# TOLL BRIDGE PROGRAM OVERSIGHT COMMITTEE MEETING MATERIALS

JUNE 2, 2011

**RE:** TBPOC Meeting Materials Packet – June 2, 2011

**RE:** Agenda No. - 2b1  
Item- Consent Calendar  
Contract Change Orders (CCOs)  
Yerba Buena Island Transition Structure (YBITS)1 CCO 10-S3  
Temporary Shoring Enhancements

## Shimmick As-Planned Bridge Jacking Operation

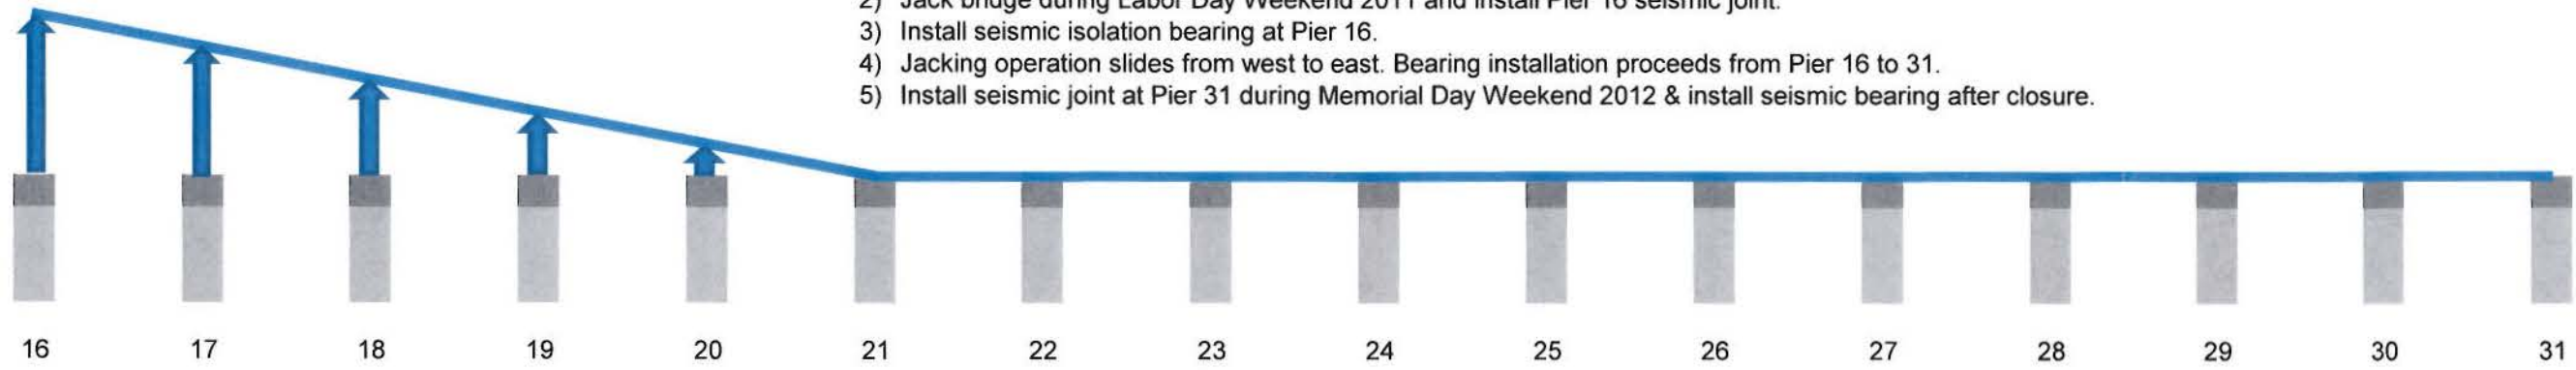
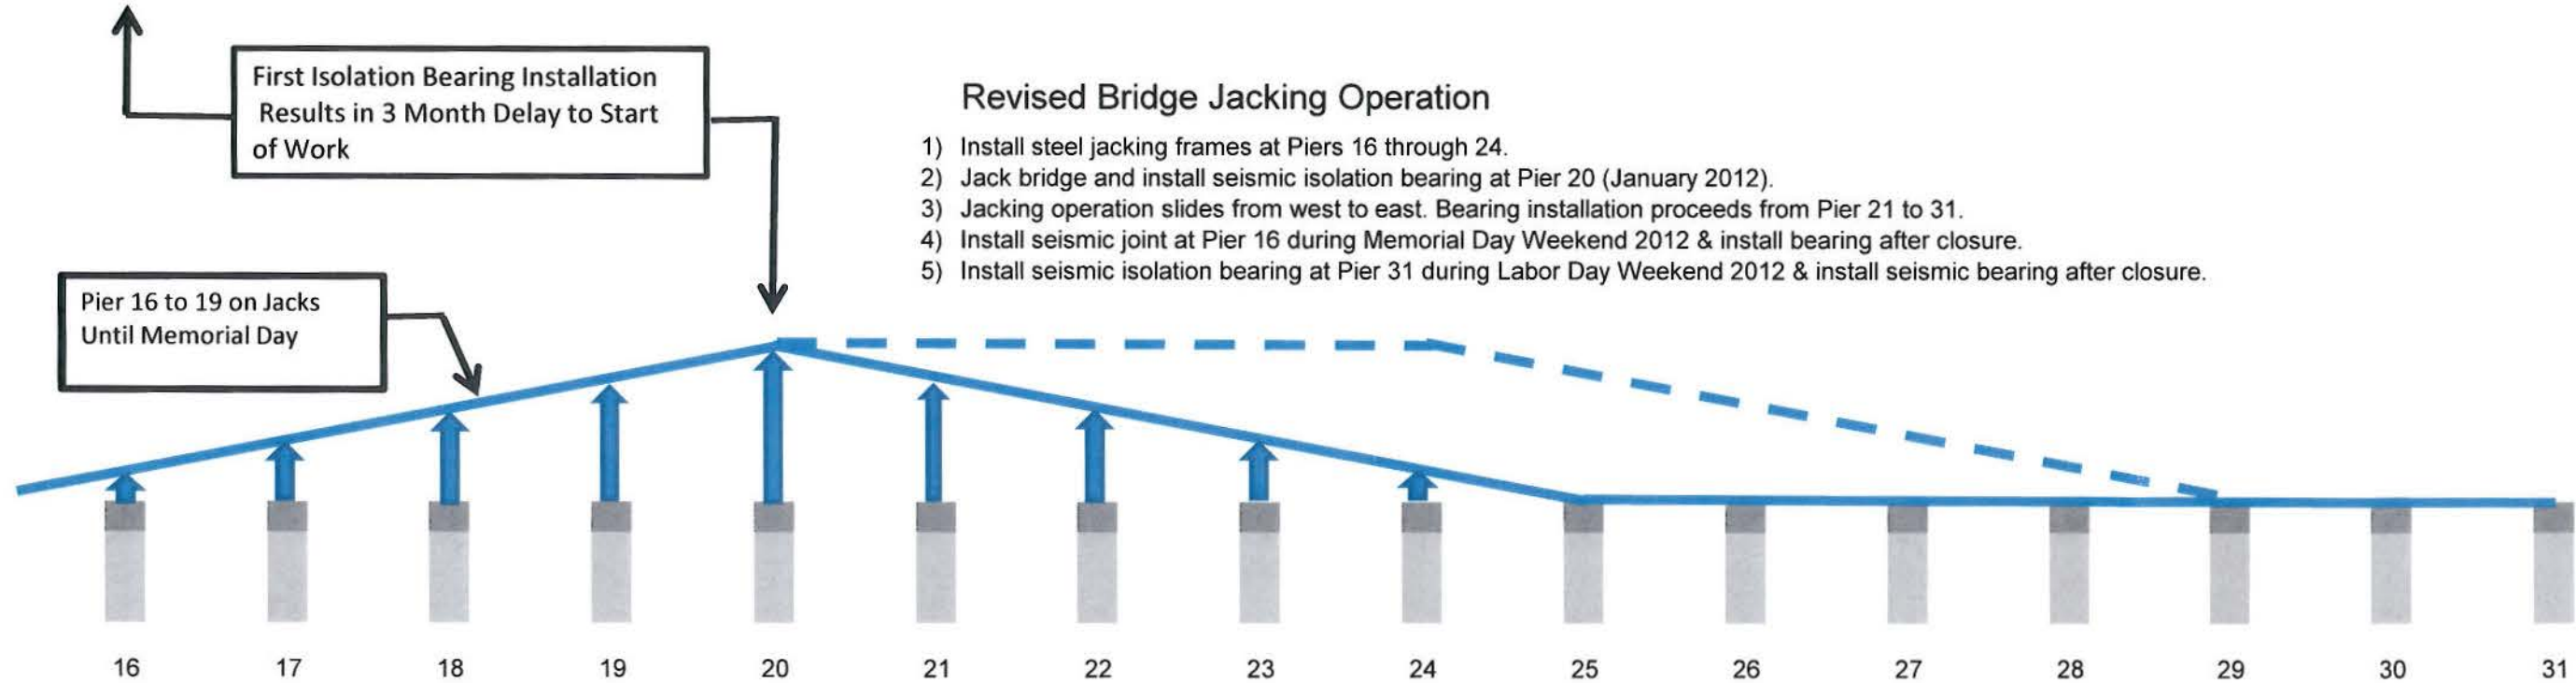
- 1) Install steel jacking frames at Piers 16 through 20 before Labor Day Weekend 2011
- 2) Jack bridge during Labor Day Weekend 2011 and install Pier 16 seismic joint.
- 3) Install seismic isolation bearing at Pier 16.
- 4) Jacking operation slides from west to east. Bearing installation proceeds from Pier 16 to 31.
- 5) Install seismic joint at Pier 31 during Memorial Day Weekend 2012 & install seismic bearing after closure.

- 1) Install steel jacking frames at Piers 16 through 24.
- 2) Jack bridge and install seismic isolation bearing at Pier 20 (January 2012).
- 3) Jacking operation slides from west to east. Bearing installation proceeds from Pier 21 to 31.
- 4) Install seismic joint at Pier 16 during Memorial Day Weekend 2012 & install bearing after closure.
- 5) Install seismic isolation bearing at Pier 31 during Labor Day Weekend 2012 & install seismic bearing after closure.
